工程指示 / 要求簡箋 ENGINEER INSTRUCTIONS (E.I.)

| 工程指示編號: | EI- 4790D | 修改版本: | D |
| 工程編號: | J 853 | 工程名稱: | 大窩坪 (延坪道) |
| 工程項目: | T3 幕牆單元件生產 (大貨) (修訂D:修改Z字碼設計及修改分格呎吋) | 日期: | 29/07/2022 |

| 名稱 | 生公企 | 制圖 | 付吉寧 | 2022.05.20 | 修改 | A | B |

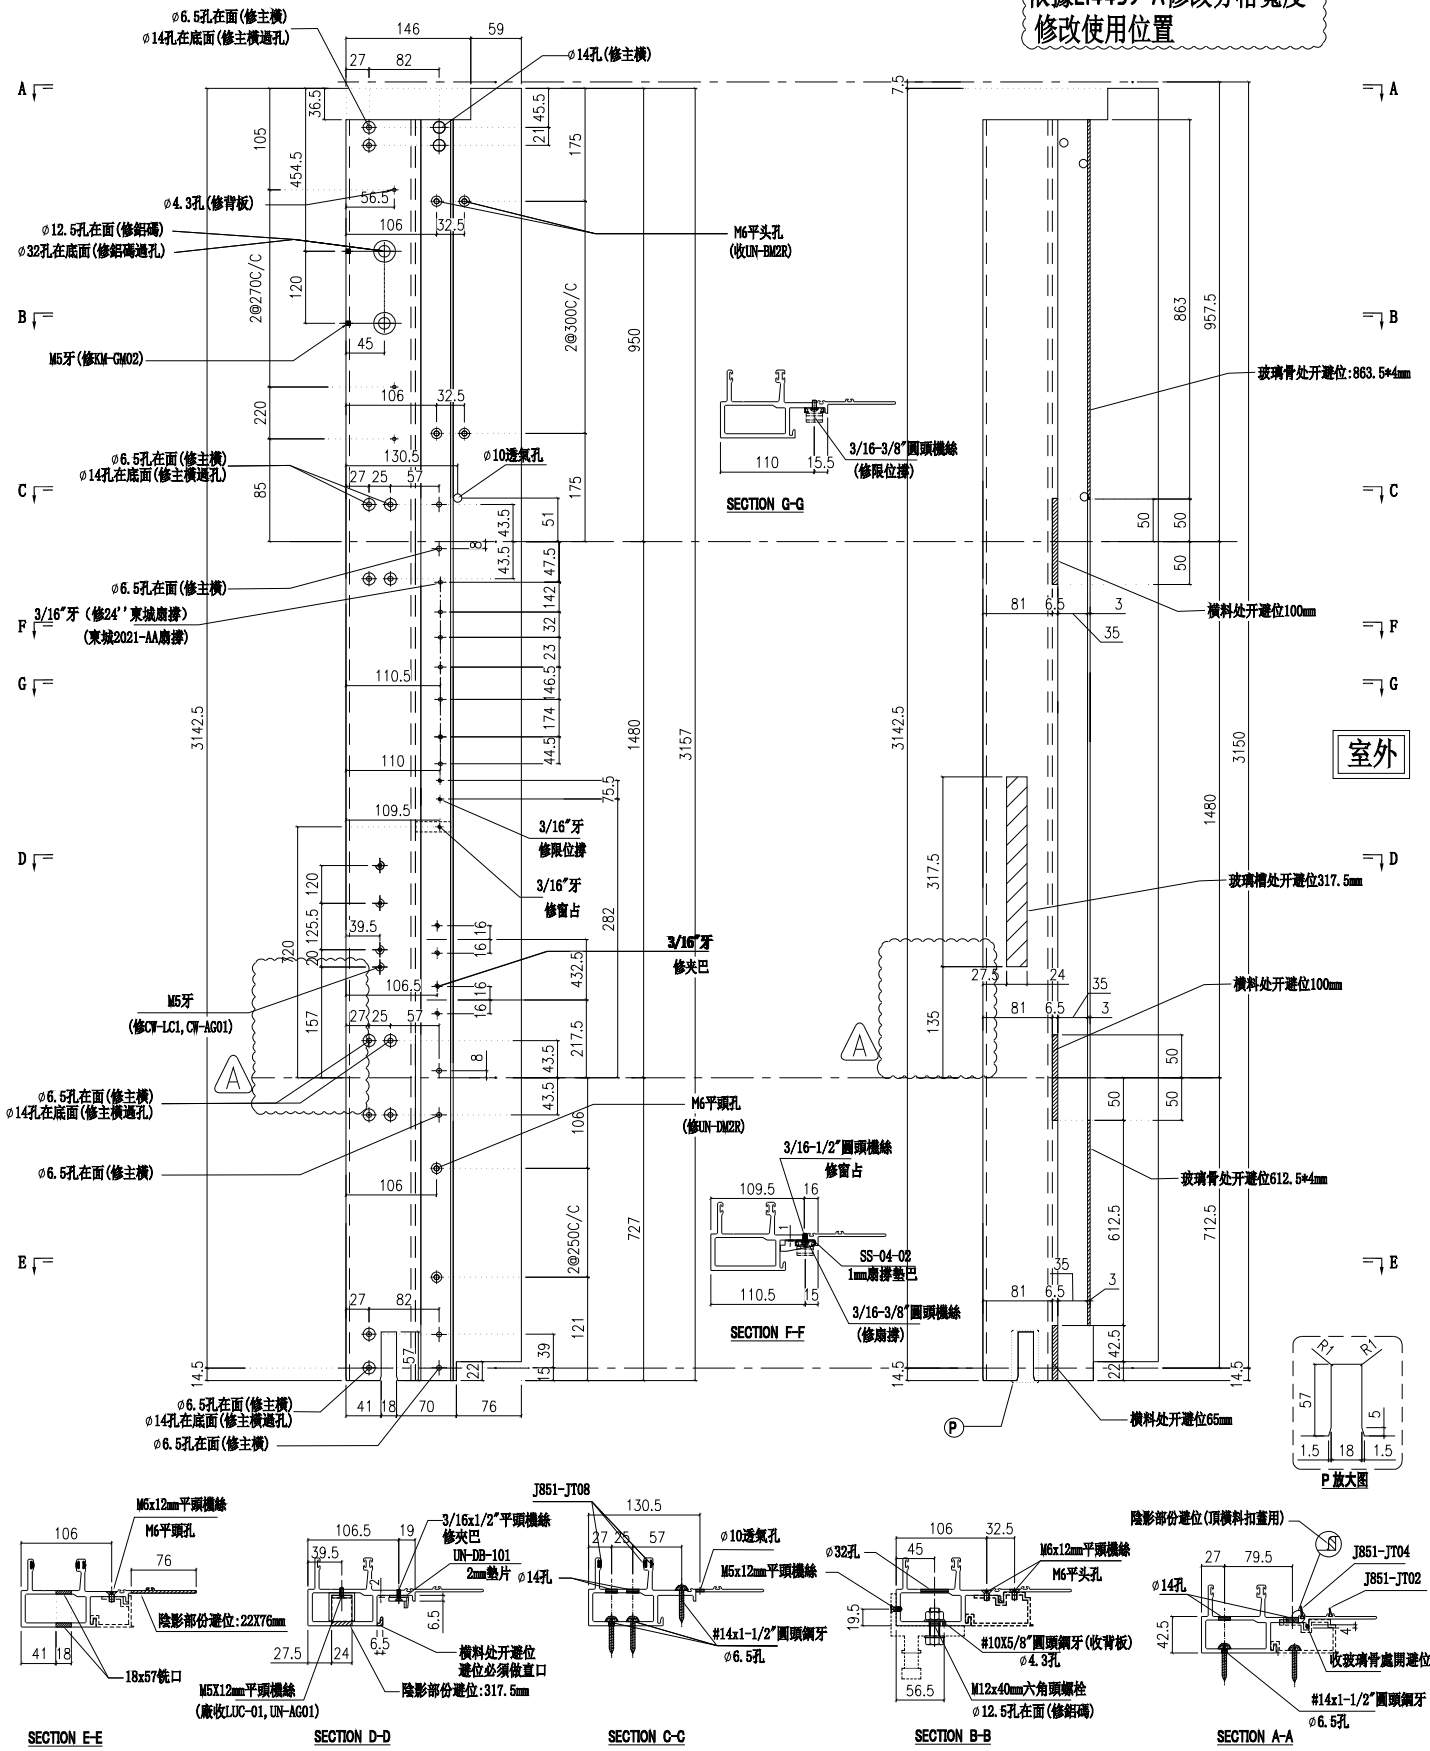
依據EI4825, 修改攔河槽及孔位尺寸

依據EI4439-A修改分格寬度
修改使用位置

| 名稱 | 生公企 | 制圖 | 付吉寧 | 2022.05.20 | 修改 | A | B |

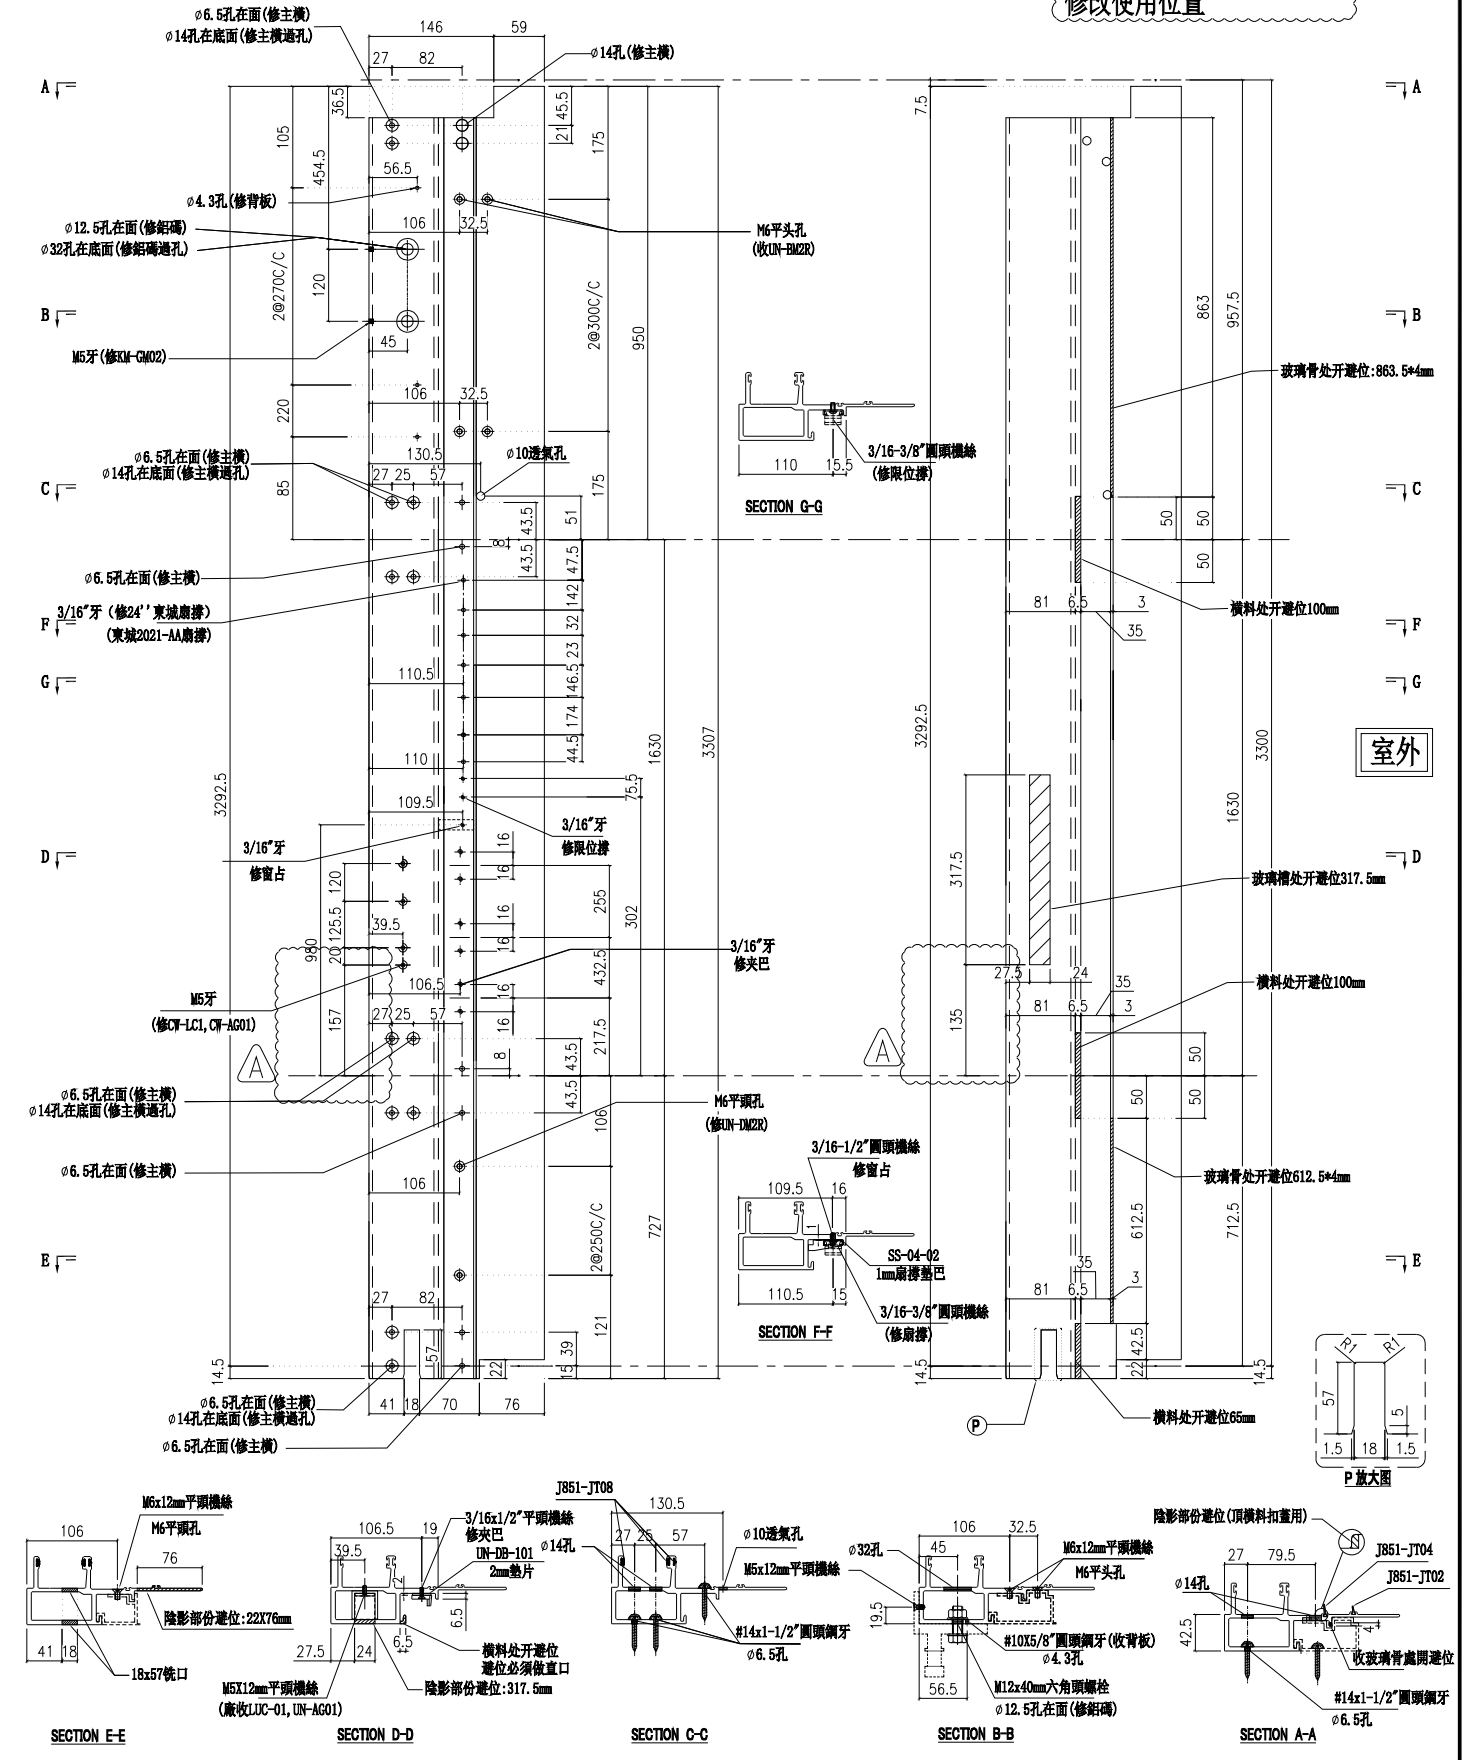
依據EI4825, 修改攔河槽及孔位尺寸
依據EI4439-A修改分格寬度
修改使用位置

| 名稱 | 生公企 | 制圖 | 付吉寧 | 2022.05.20 | 修改 | A | B |

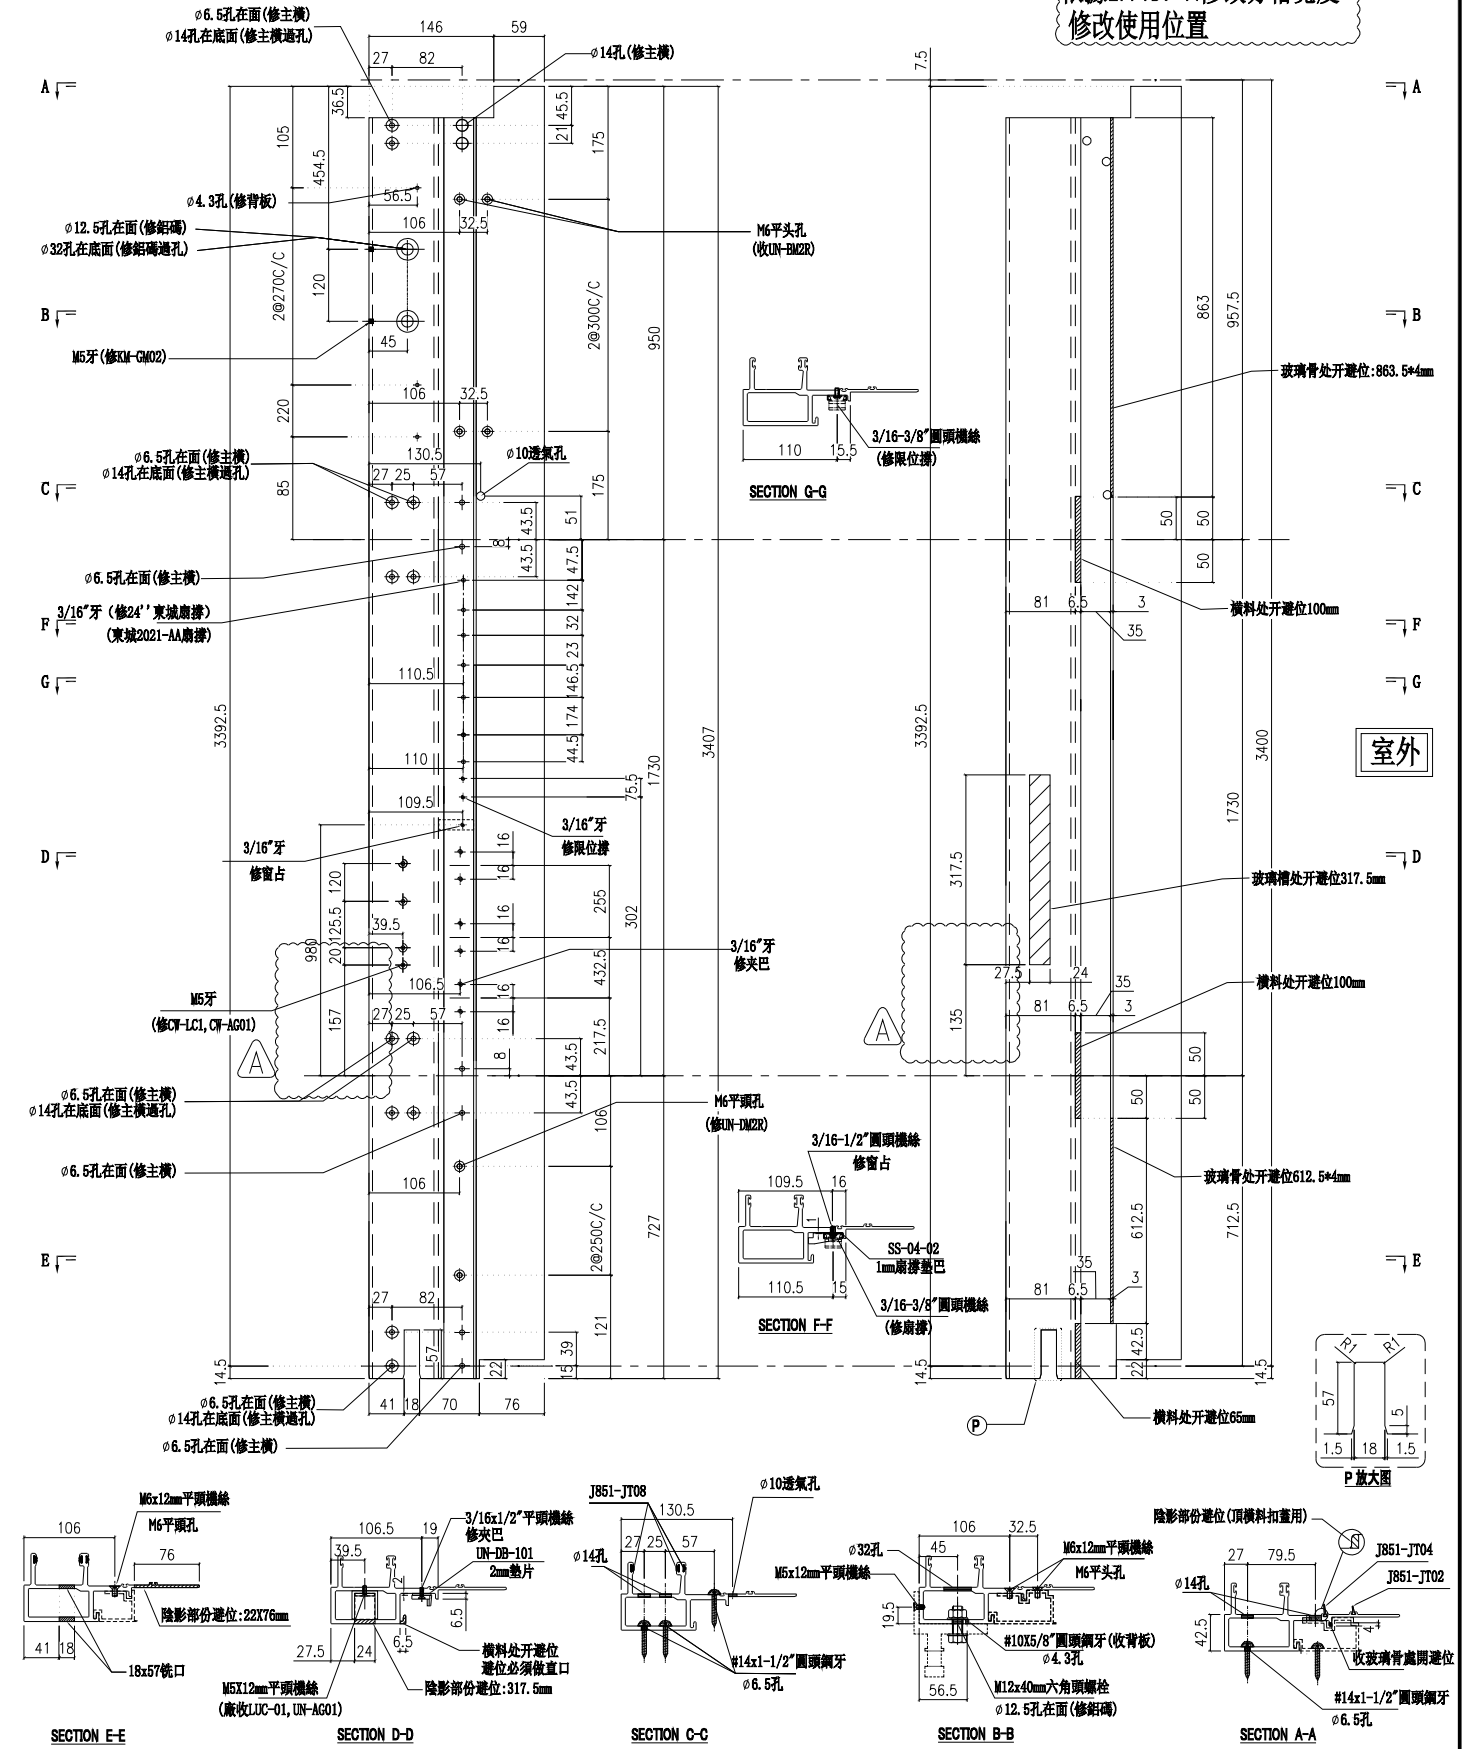
依據EI4825, 修改攔河槽及孔位尺寸

依據EI4439-A修改分格寬度
修改使用位置

| 名稱 | 生窗玉組裝圖 | 制圖 | 付吉寧 | 2022.05.20 | 修改 | A |

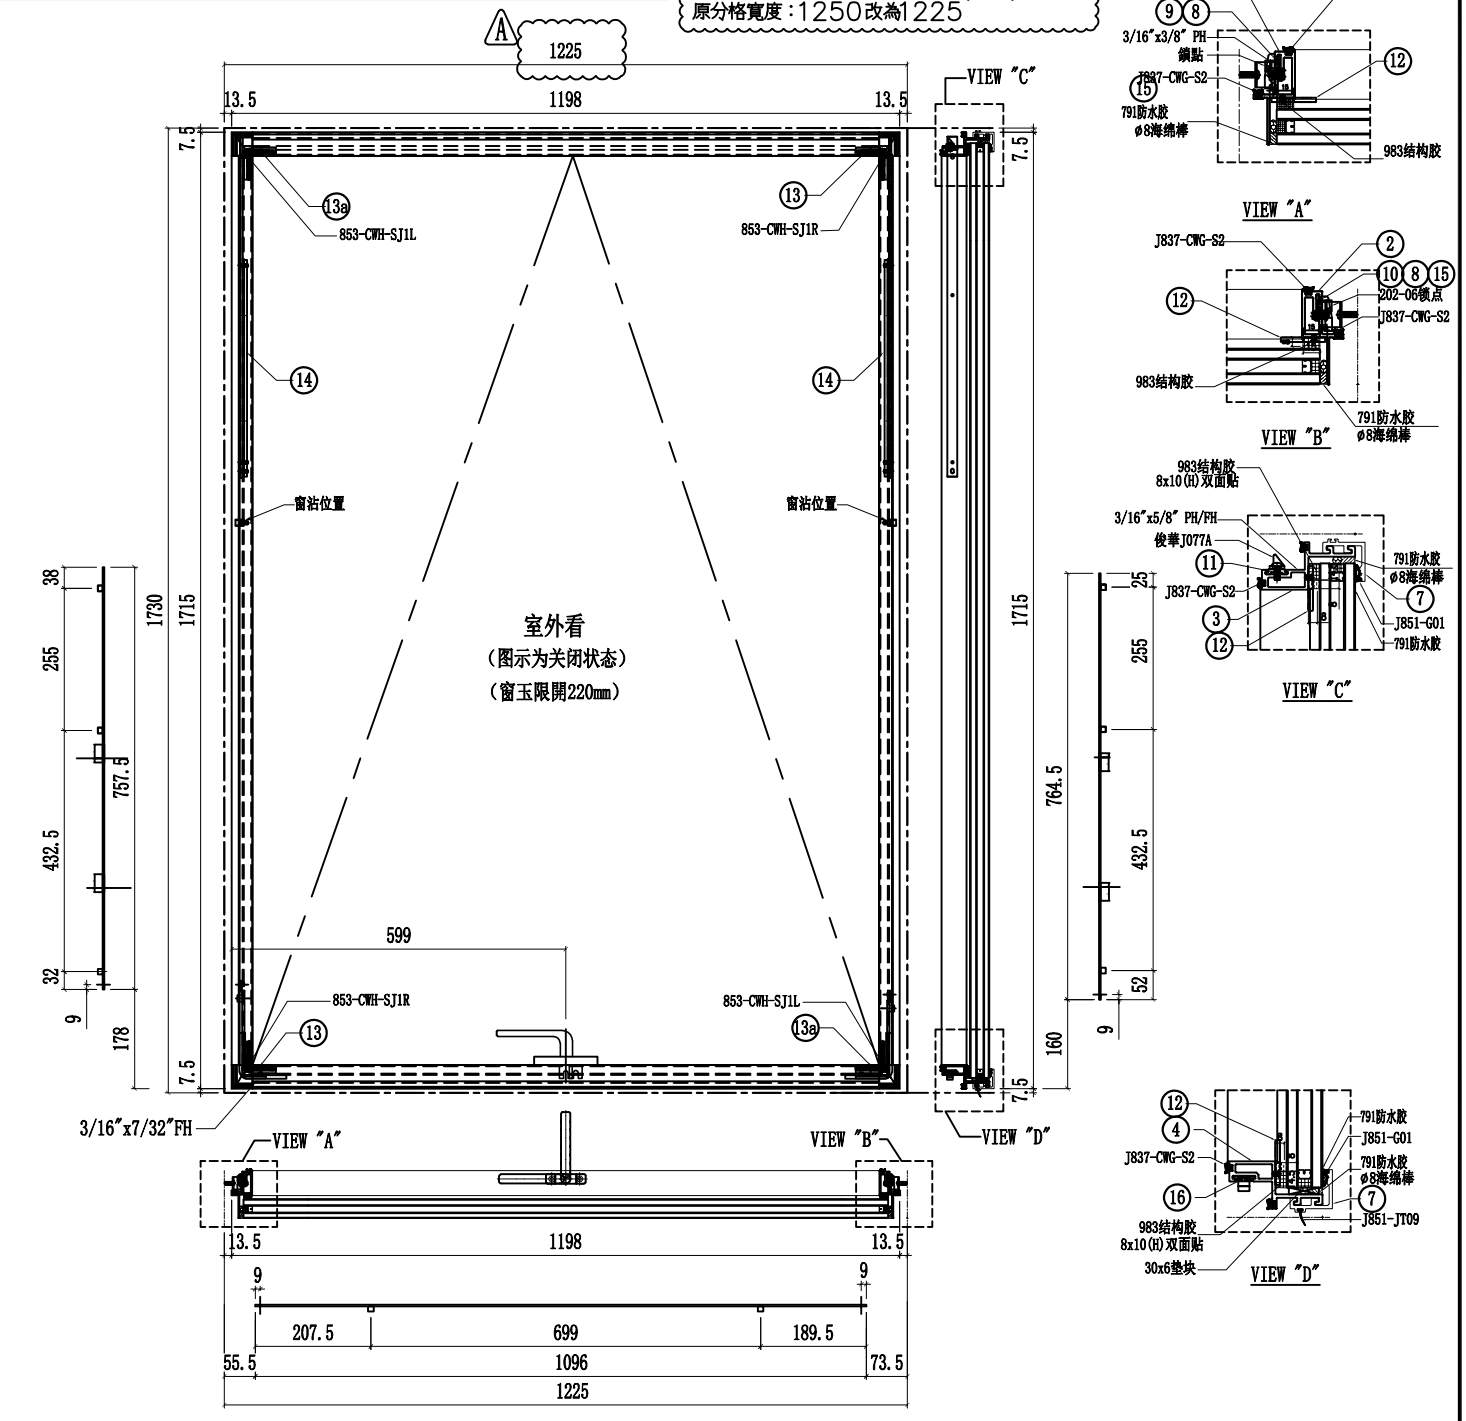
依據E144.39-A 修改分格寬度, 圖號, 使用位置
原分格寬度: 1250改為1225

| 名稱 | 生窗玉組裝圖 | 制圖 | 付吉寧 | 2022.05.20 | 修改 | A |

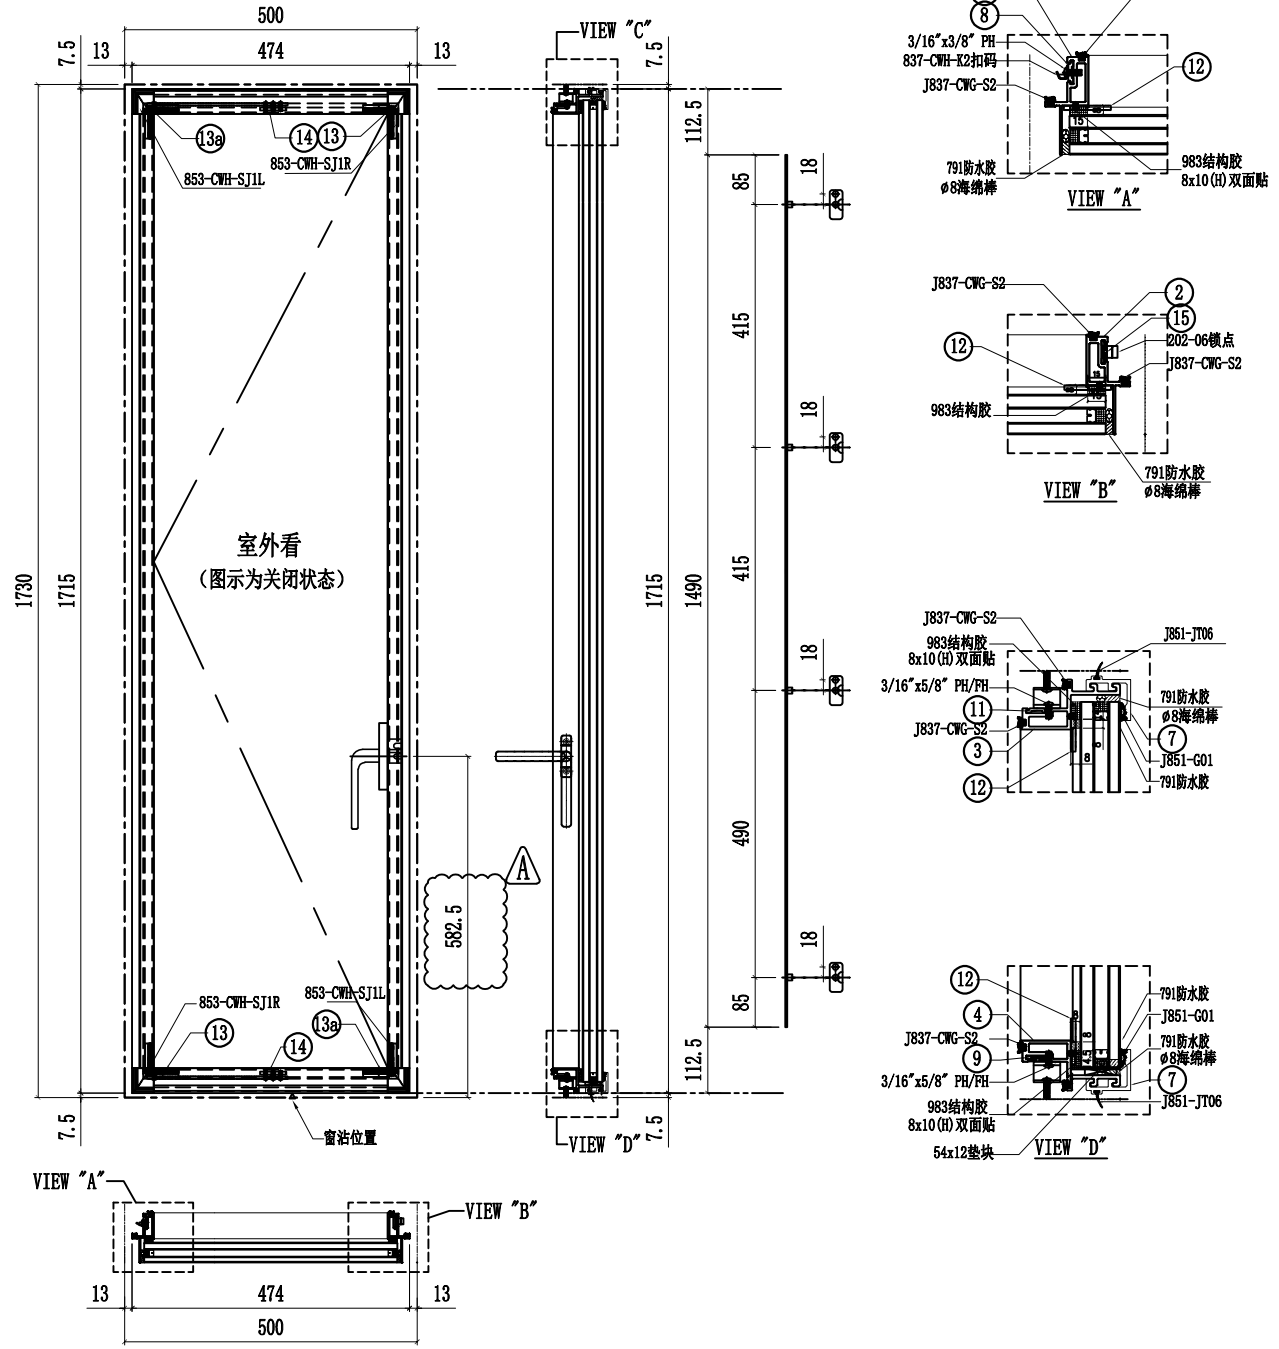
雲線處依據EI-4891 修改手柄高度
